Technical Service Information

THM 3T40 (125C) REVISED DRIVE CHAIN SPECIFICATIONS

Figure 1

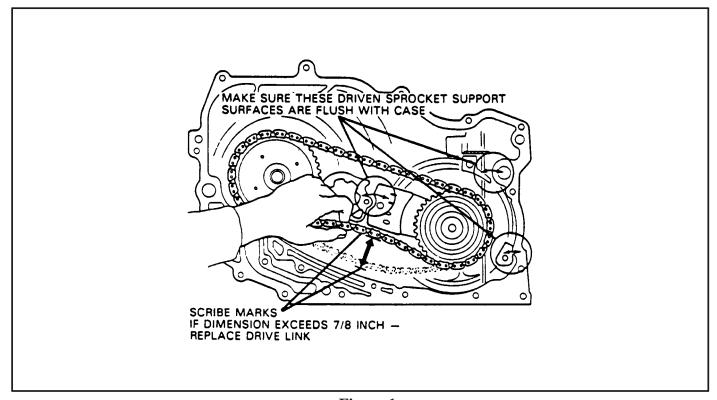
The drive chain specification has been revised to minimize noise. The previous specification was 1 1/16". The new specification is 718". Refer to Figure 1.
